**From:** Amadi, Eric A - DNR  
**Sent:** Tuesday, November 23, 2021 6:25 PM  
**To:** Julie A Zimdars  
**Subject:** FW: BRRTS 02-41-553761 and 06-41-560068 Connell Wabash Site - RAOR Addendum/Pre-Design Work Plan (Rev 2)  
**Attachments:** BRRTS 0241553761 & 0641560068 Connell Wabash RAOR Addendum R2 Sep 28 2021.pdf

Hi Eric – On behalf of Connell Aluminum Properties, attached is the *Addendum (Revision 2) to the Remedial Action Options Report (RAOR) and Pre-Design Sampling Work Plan* for the Former Koppers Tar Plant and Wabash Alloys Site that incorporates WDNR comments received on July 9, 2021.

**Addendum (Revision 2) to Remedial Action Options Report (RAOR)  
and Pre-Design Sampling Work Plan - Connell Aluminum Properties, LLC  
Former Koppers Tar Plant and Wabash Alloys Site  
9100 S. 5<sup>th</sup> Avenue, Oak Creek, WI 53154  
BRRTS# 02-41-553761, FID#241379050  
Connell VPLE BRRTS #:06-41-560068**

**FIGURE 6**  
FIGURE C35 (REV. SI REPORT)

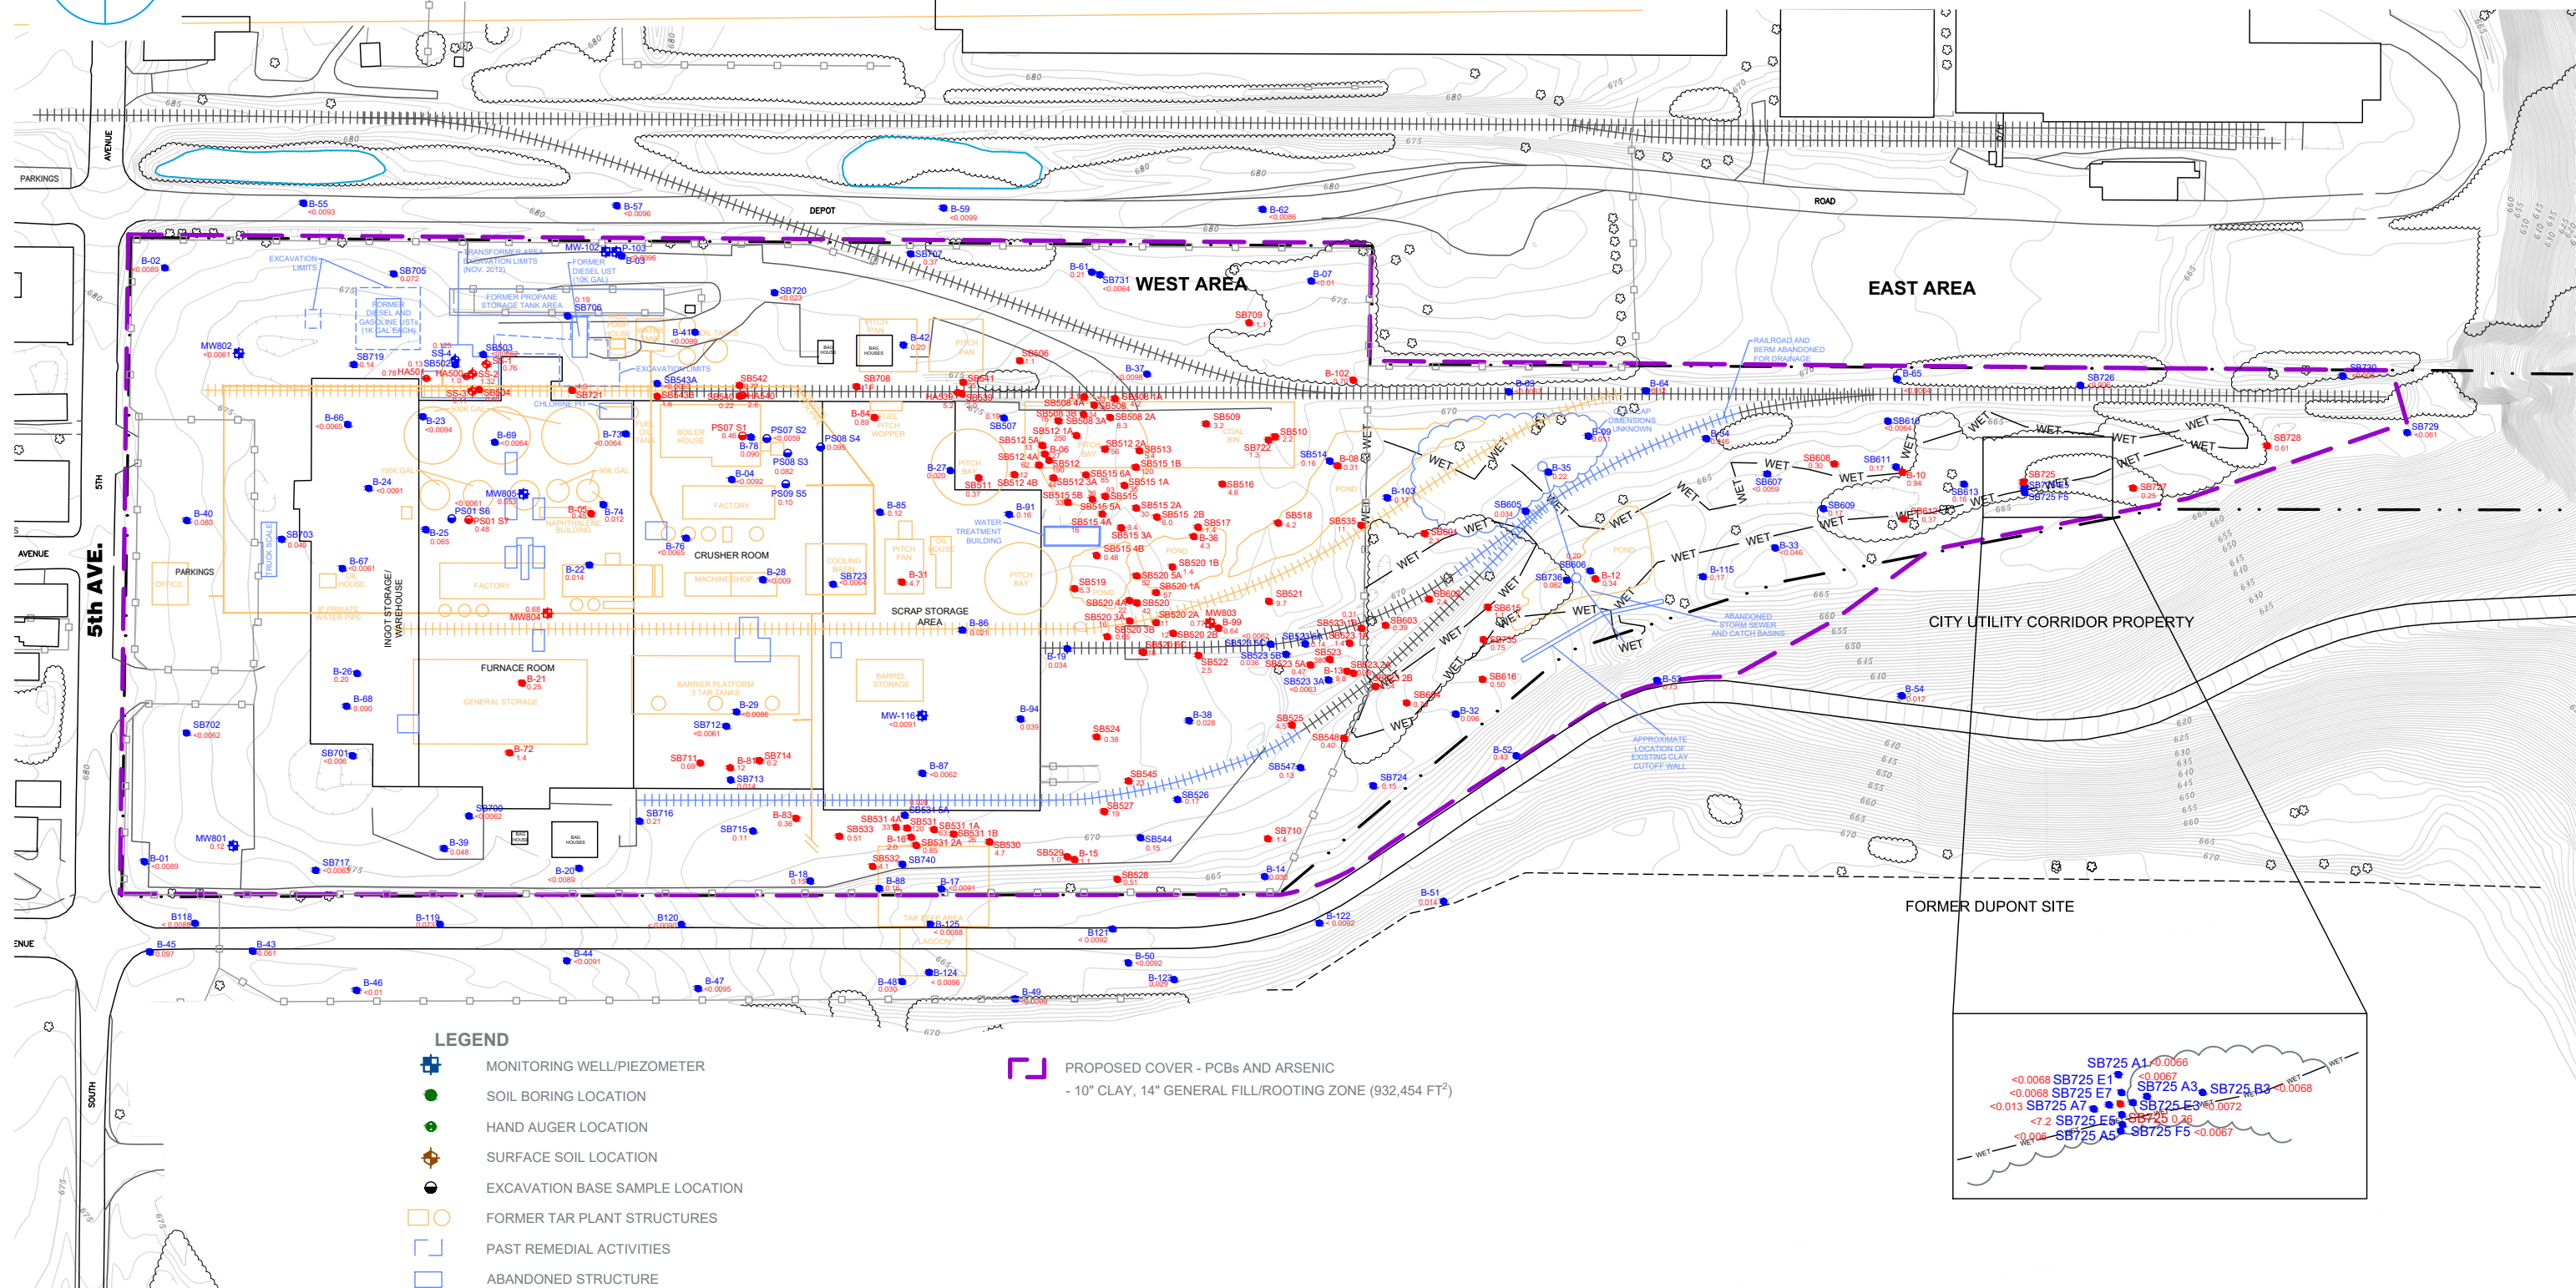
- Figure 5 – Revised RAOR Figure 8 - PCB and Arsenic Soil Barrier (Alternative S-3) for purposes of showing the revised estimated cap extent in both the western and eastern areas.
- Figure 6 – Revised Figure C35 SI Report – PCB Aroclor 1242/1248/1254/1260 Soil Concentrations (0-4 feet bgs) for purposes of showing PCB sampling results and proposed cap extents.
- Figure 7 – Revised Figure C1 SI Report – Arsenic Soil Concentrations (0-4 ft bgs) for purposes of showing arsenic sampling results and proposed cap extents.

**FIGURE 8**

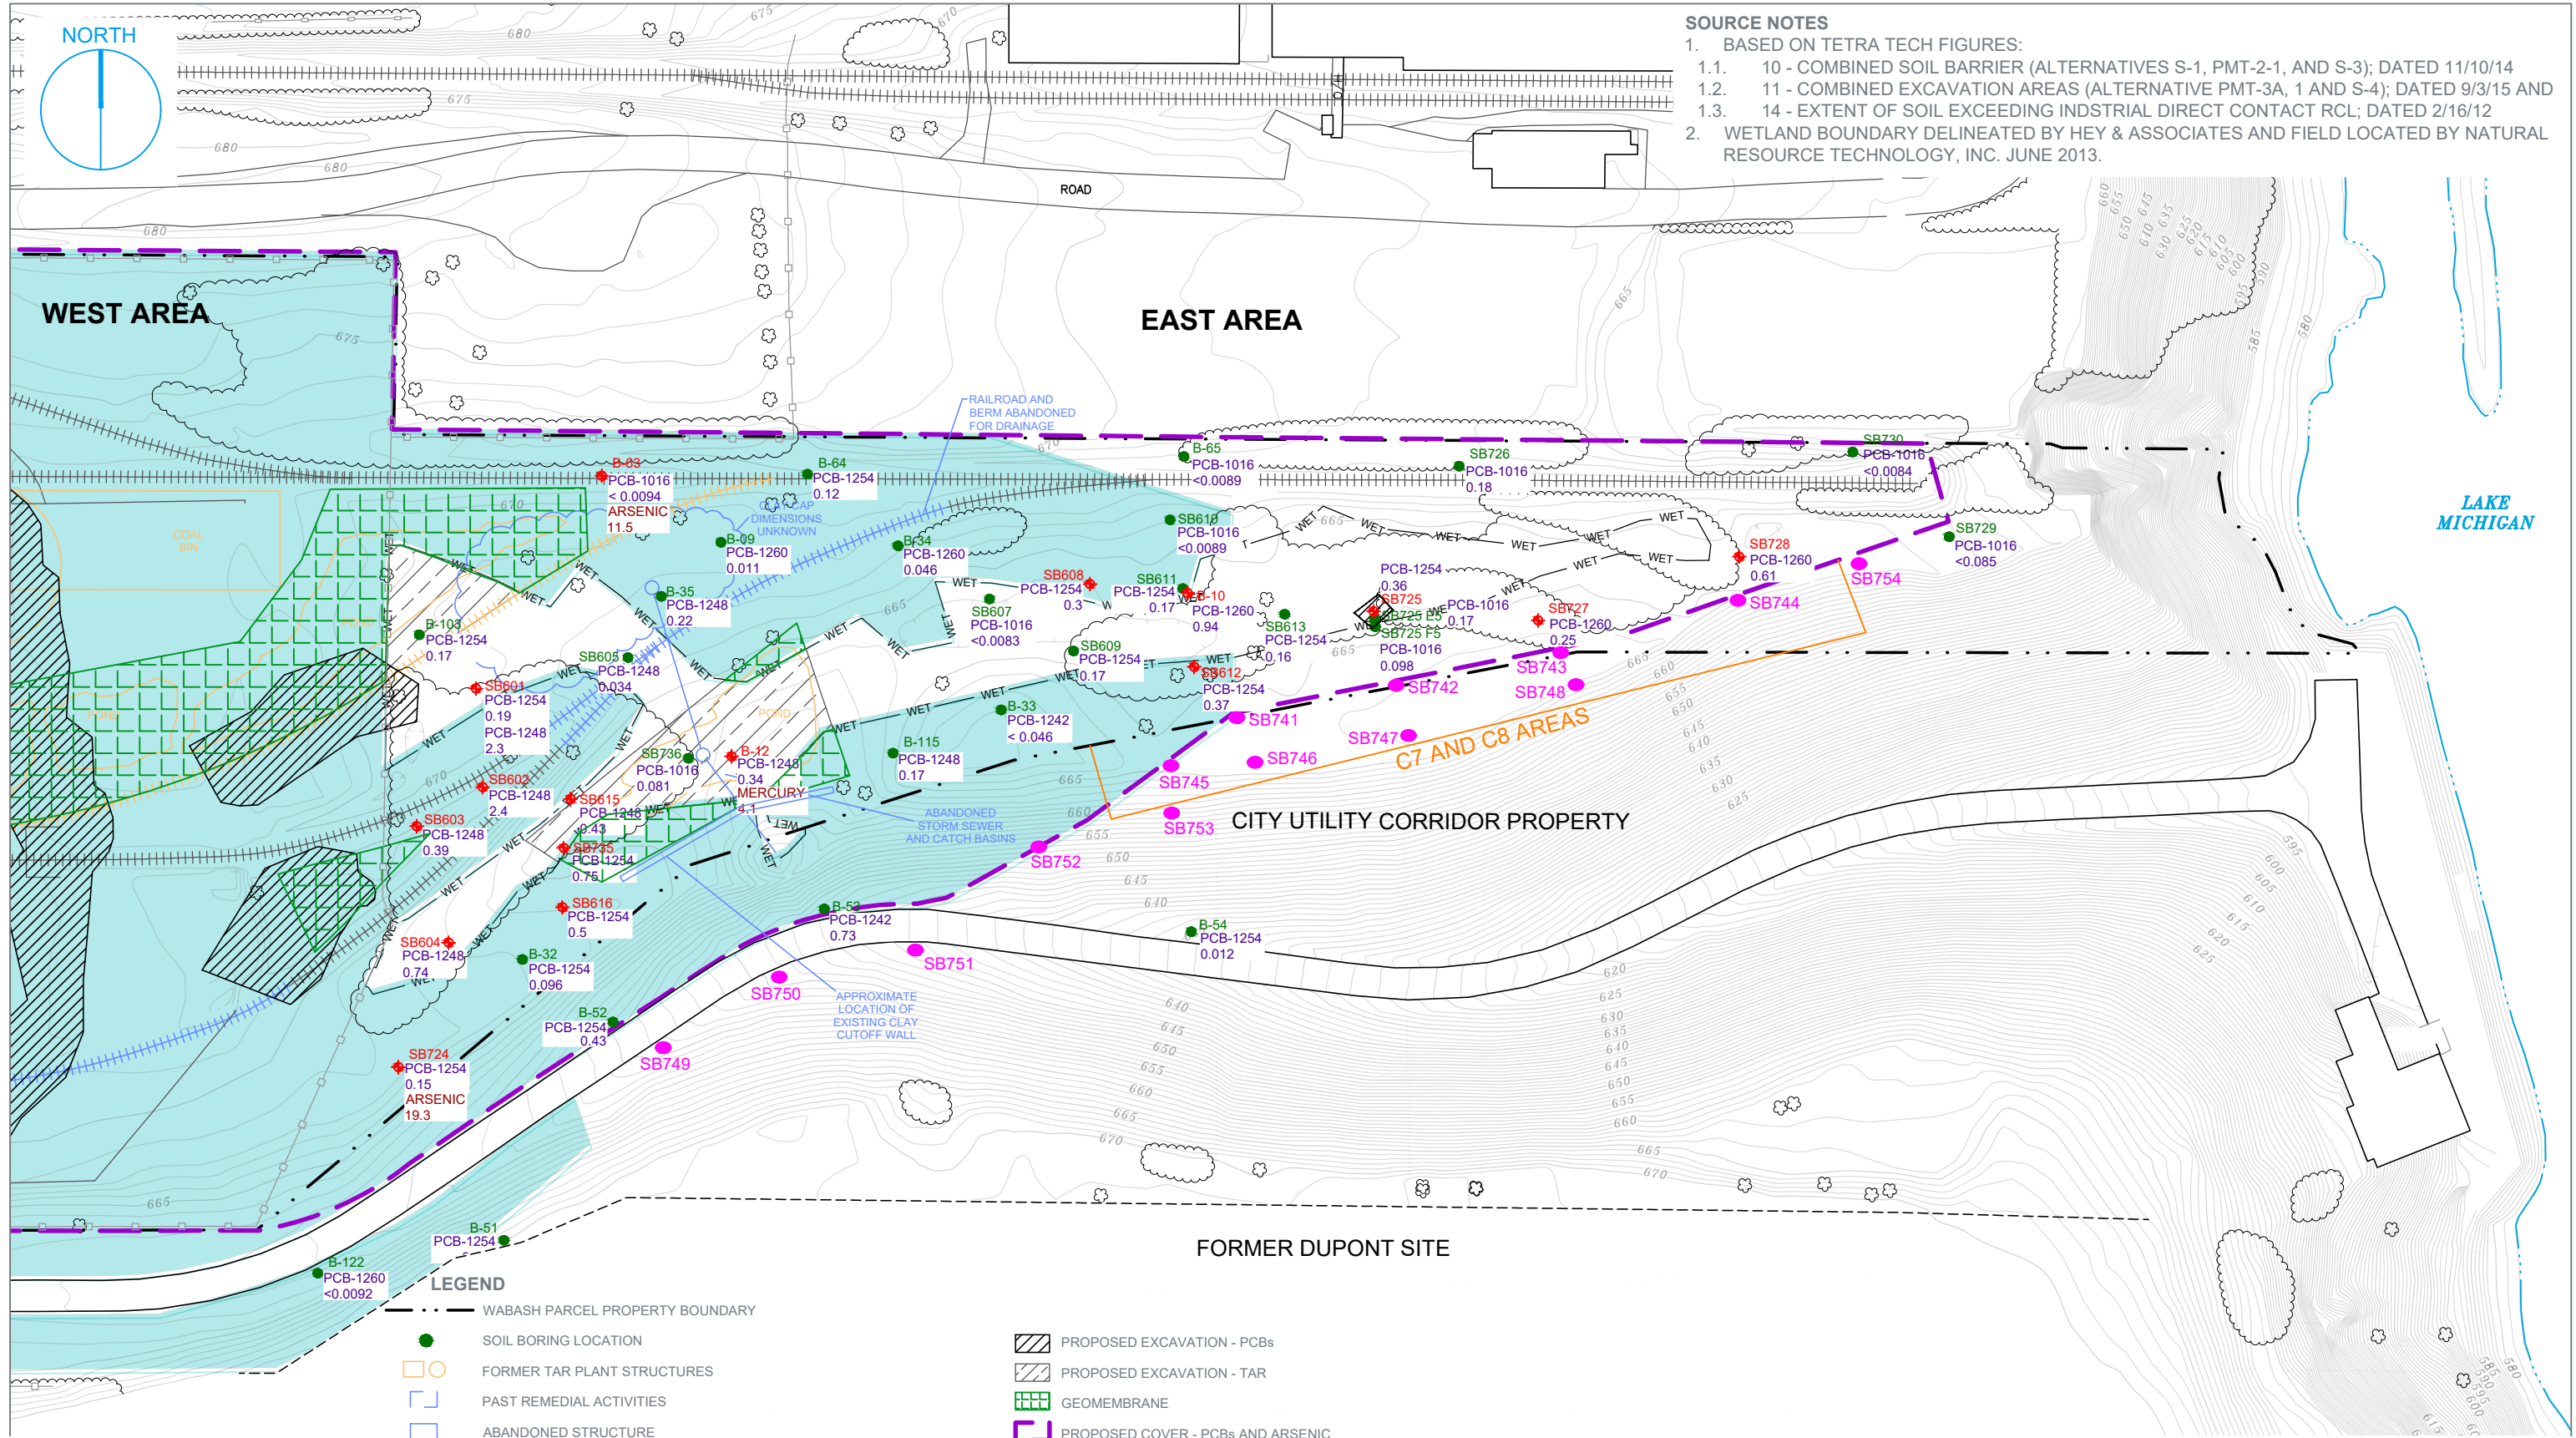
Ramboll has prepared a new figure (Figure 8) to illustrate the additional proposed capping extent in the eastern area, to include both wetland and non-wetland areas that exceed respective non-industrial RCLs.

- Figure 8 – PCB and Arsenic Soil Barrier – East Area for purposes of showing the additional proposed cap extent. The additional pre-design sampling locations related to comments C7 and C8 and eastern City corridor are shown (14 borings labeled SB741 to SB754). Nine (9) of the sampling locations are proposed to be performed on the City Utility Corridor property, and as such, access for these will be requested from the City. WDNR comments C1 through C6 are not applicable as the cap is being extended to the property boundary or beyond to the City property in these areas, and largely coincides with the proposed cover for PAHs (Beazer plans).

PROJECT NO.  
 2095/6.1  
 FIGURE NO.  
 C4

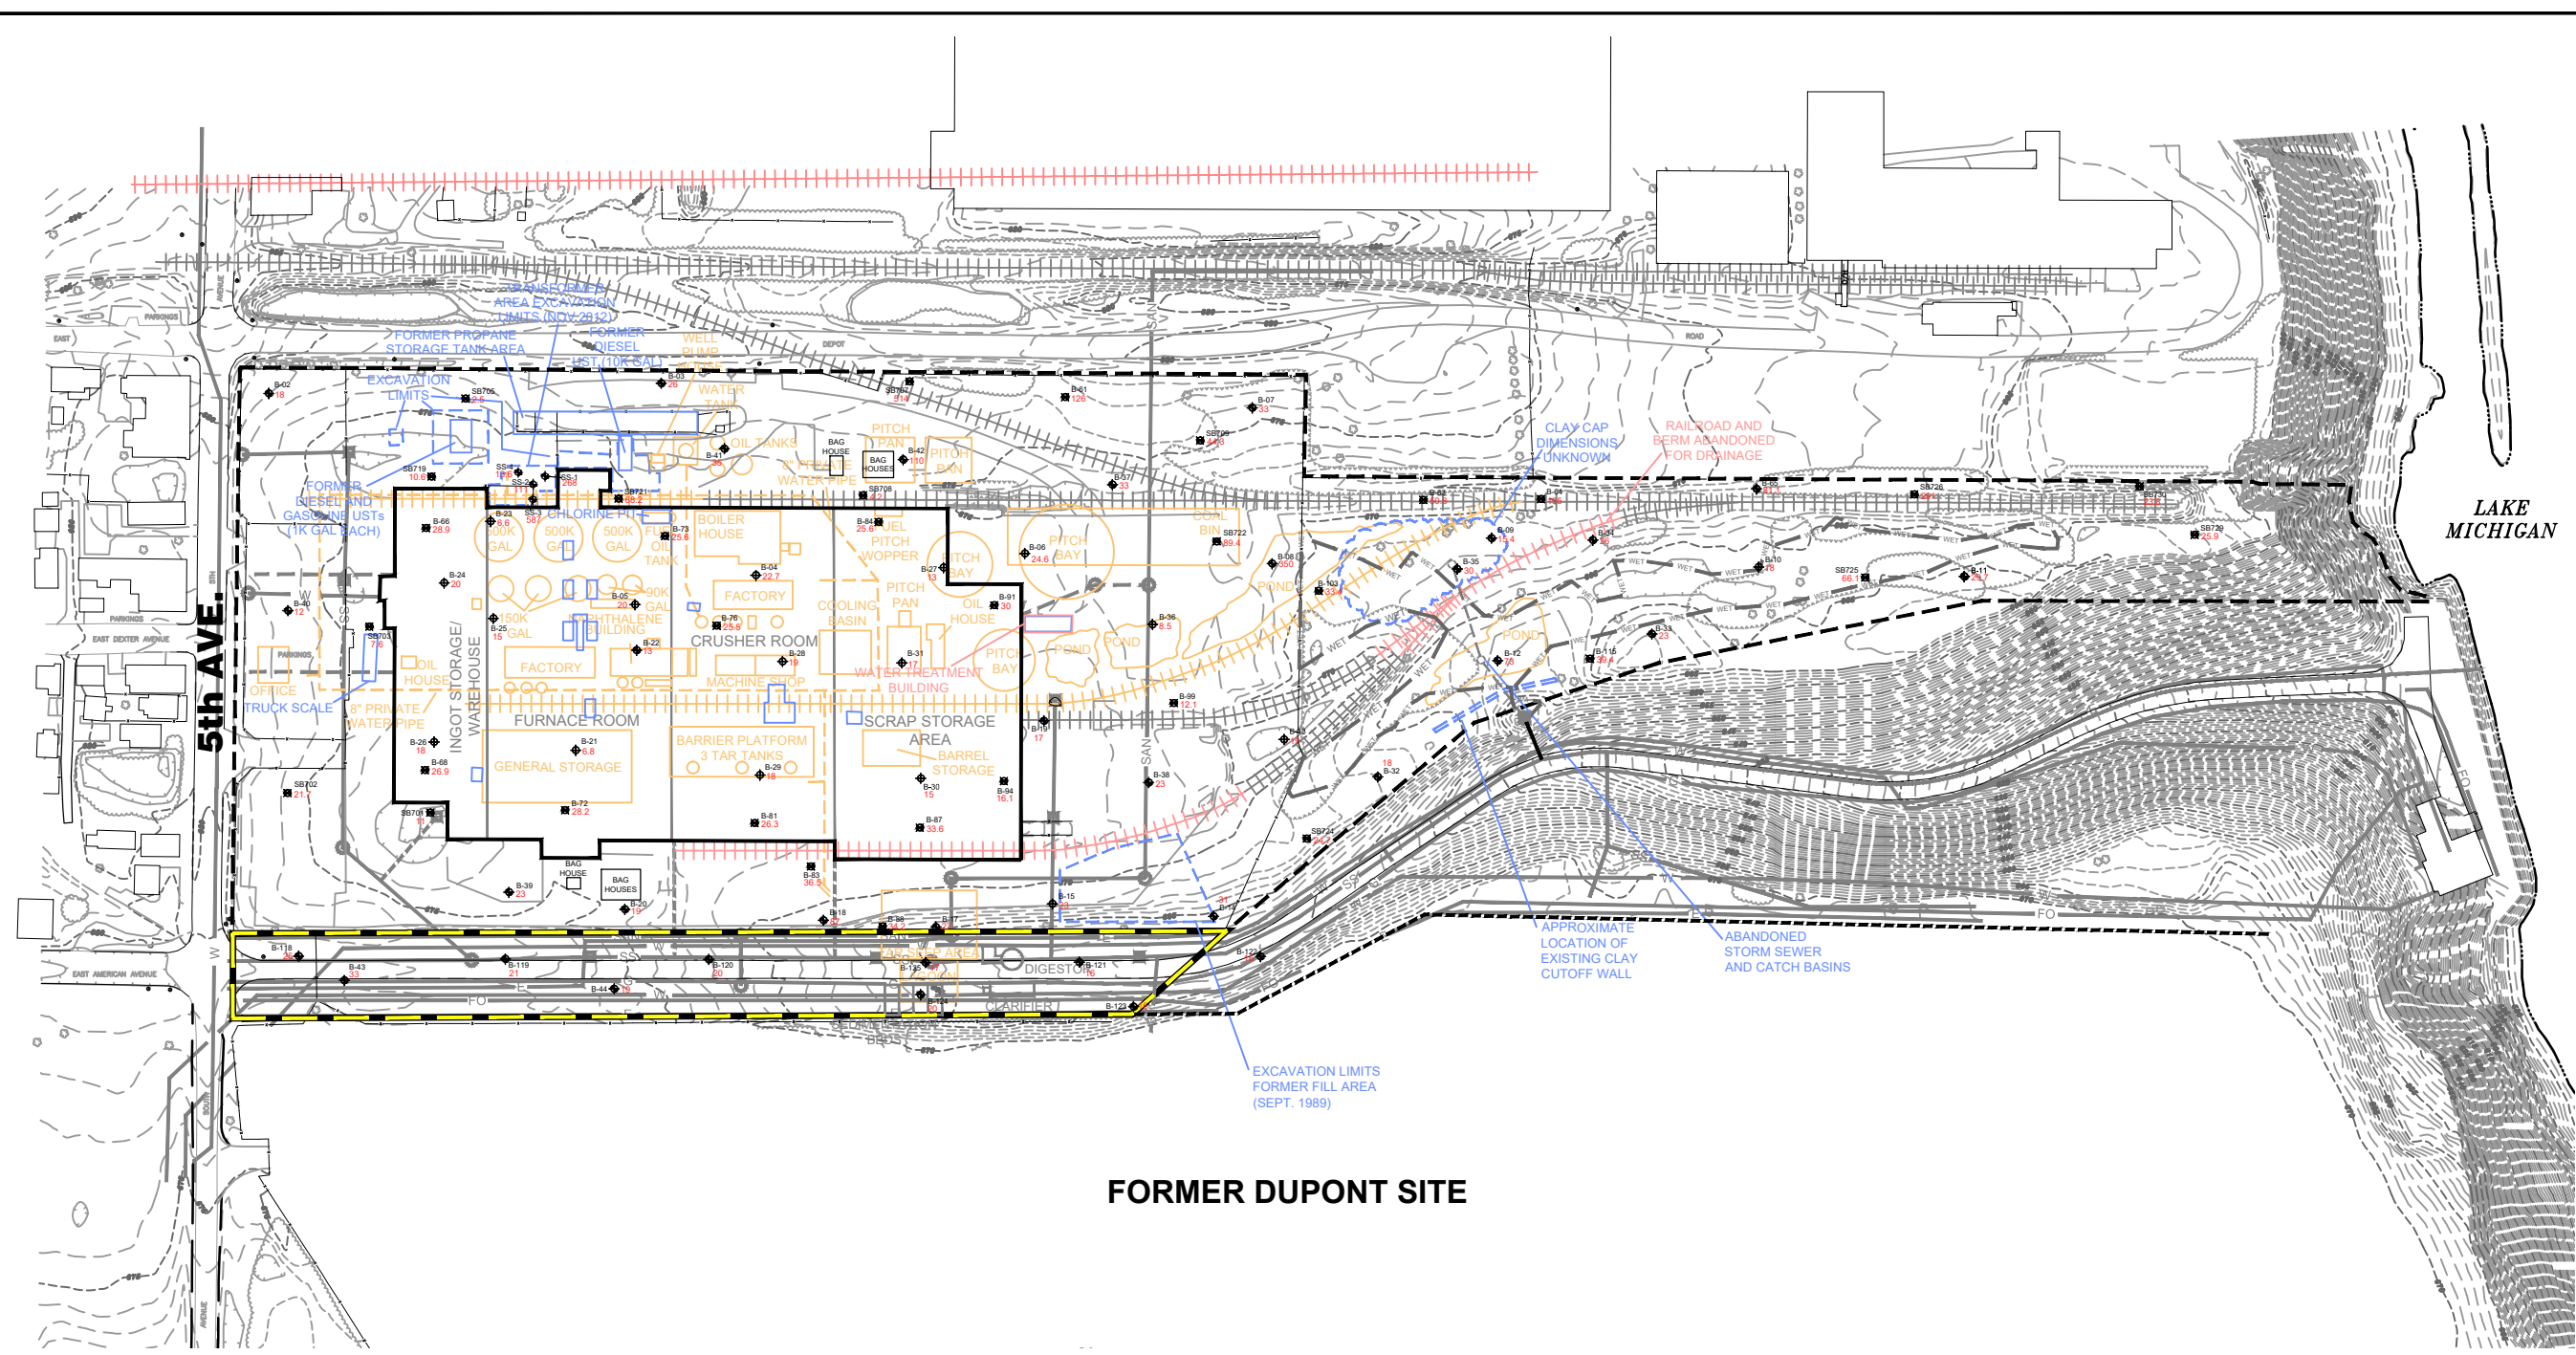
On January 27, 2014, NRT resubmitted the SI Report Figures C4 (Chromium, 0-4 ft bgs) and C8 (Silver, 0-4 ft bgs) after realizing an error on the figures that did not match the tables for chromium and silver (NRT transmittal dated January 27, 2014 is attached). Note that the data for B-08 has been corrected on these figures and are attached.
